Attachment 1: Figure 1

This document is an Addendum to the Environmental Impact Report (EIR) for the Rimforest Storm Drain Project (project) addressing the construction and maintenance of a series of drainage facilities to address historic erosion and landsliding in the southern Rimforest community (SCH# 2015051070). This Addendum has been prepared based on changes to the detailed design plans and project disturbance area discussed in the Project EIR certified in 2017 by the San Bernardino County Flood Control District (District). A description of the design changes and detailed design plan are presented in Section 3, Project Design Changes, of this EIR Addendum.

Attachment 1 – Figure 1

Figure 1
Changes to Project Design

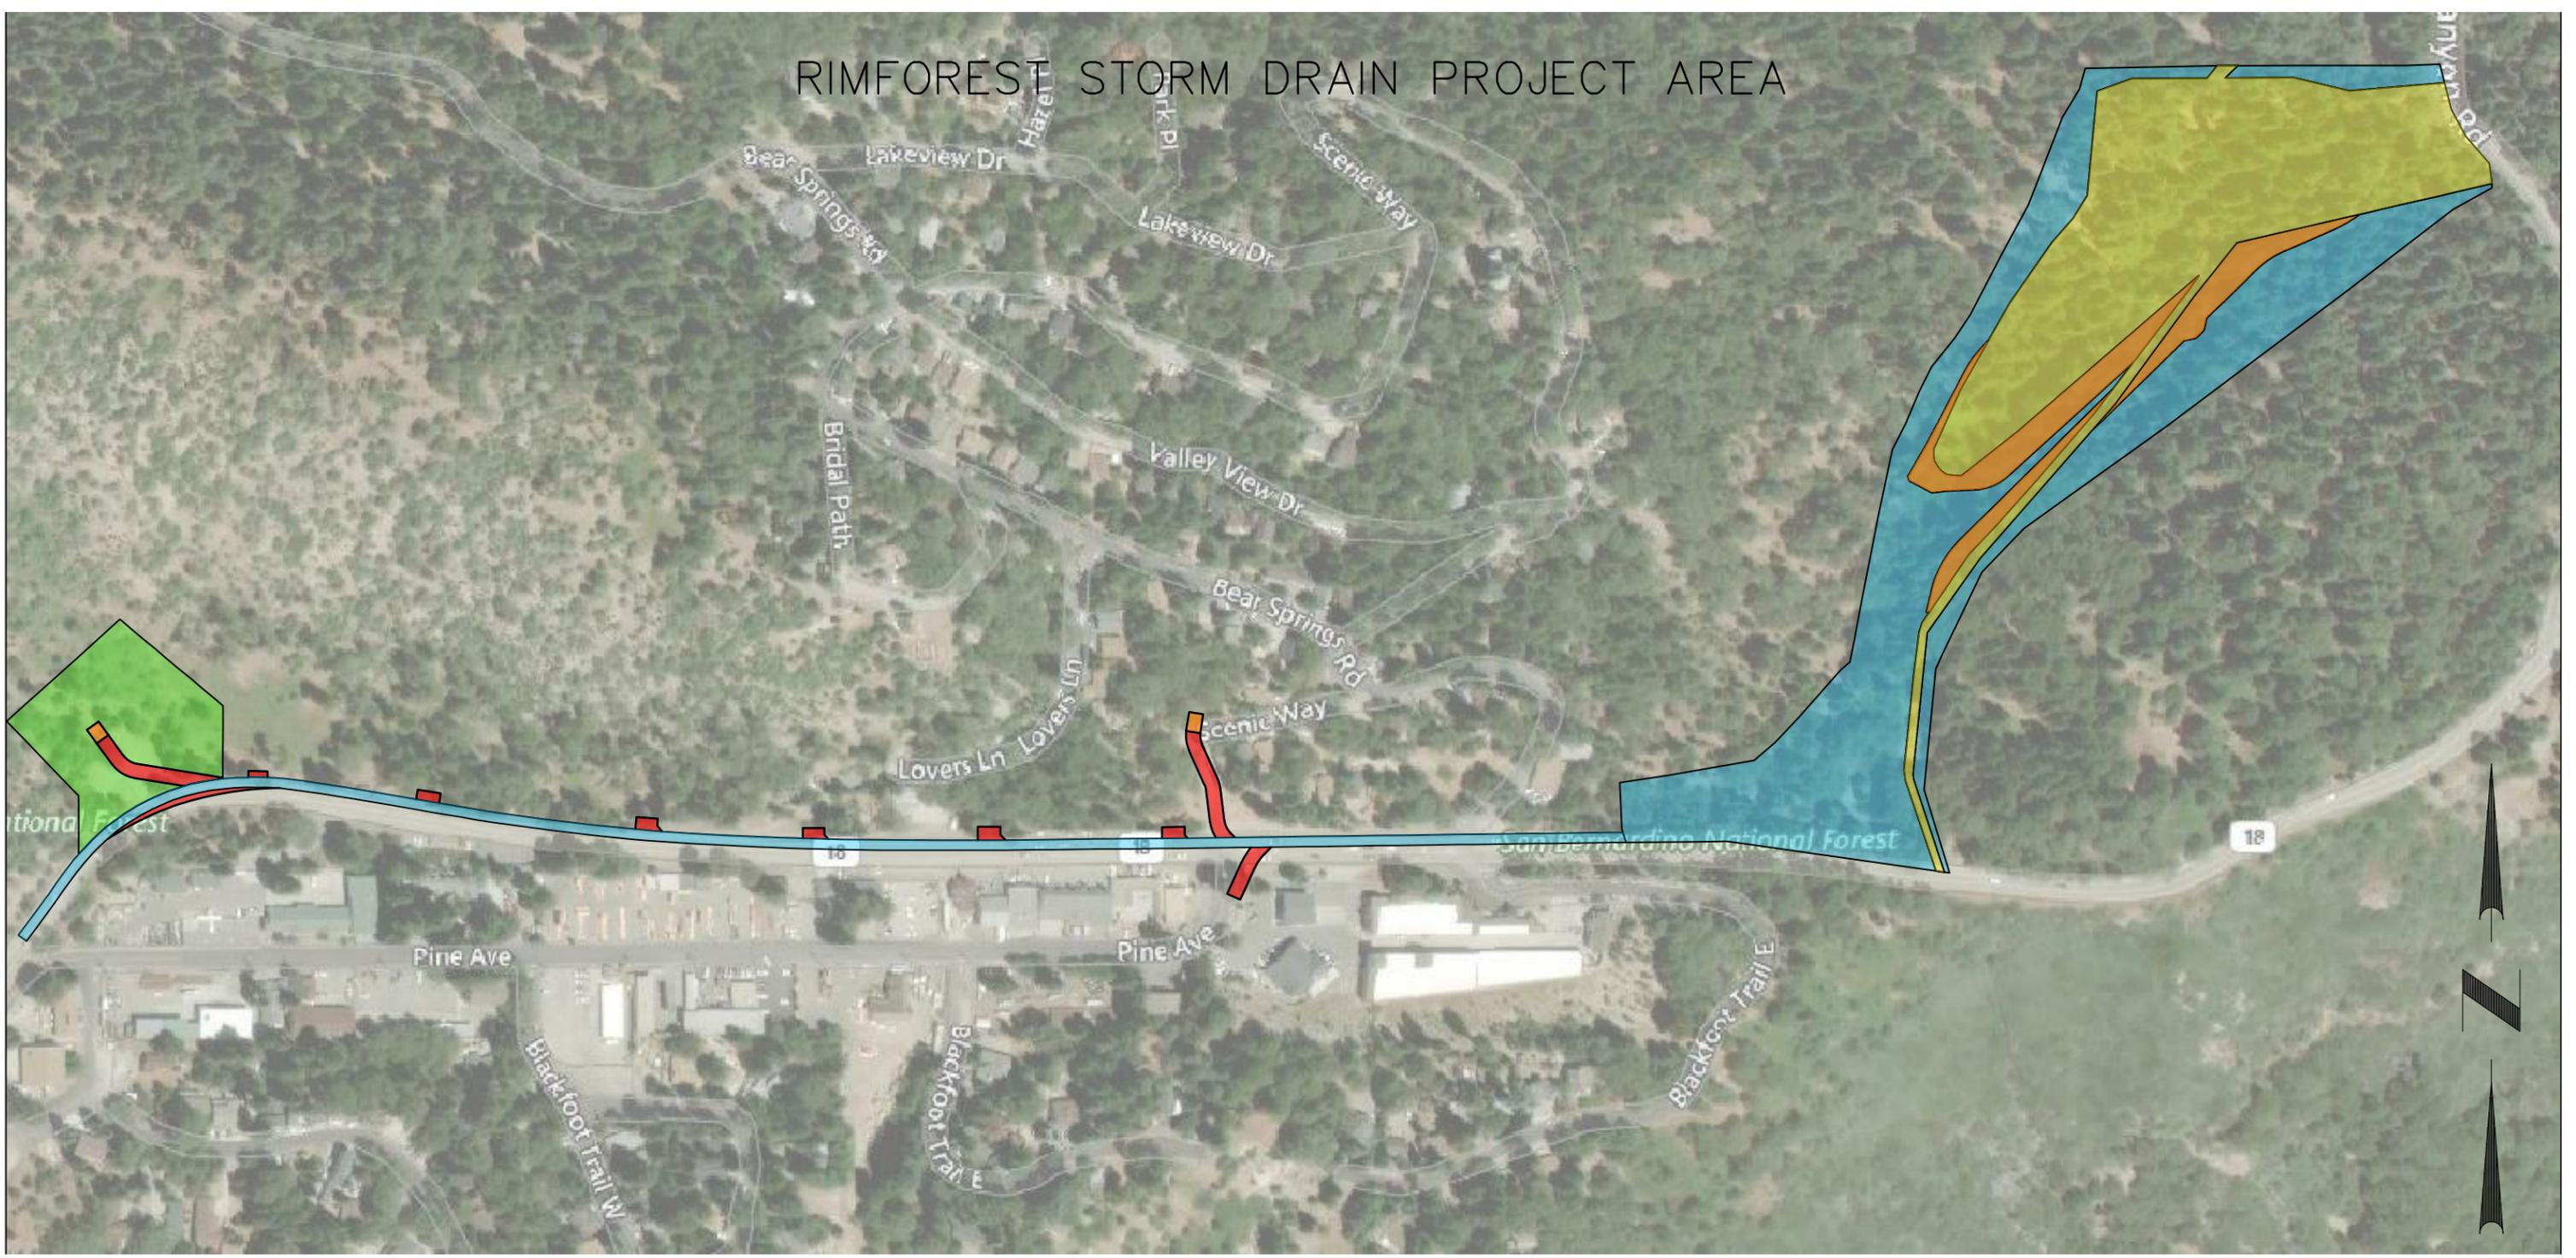
The project design essentially remains the same. However, a few modifications were made during final design (see Figure 1).

- **Grading Modifications.** Due to grading difficulties, the size of the permanent impact area within the basin has increased. In order for the basin to work properly and provide adequate access for maintenance, slopes are required to extend to match grade.

- **Drainage Inlet Modifications.** A drainage course exists at the top of Scenic Way. During final design, it was determined that in order to prevent Scenic Way from washing out, installation of a concrete apron with headwall and trash rack would be necessary at the inlet. Similarly, the drainage course at the fire station would be modified to prevent erosion in this area. All of the new temporary impacts along Highway 18 are associated with drainage inlets.
- **Temporary Road Access.** Some temporary pavement will be installed along Highway 18 in order to allow two-way traffic while constructing the storm drain in Highway 18. The road width would be increased up to 9 feet in some areas.
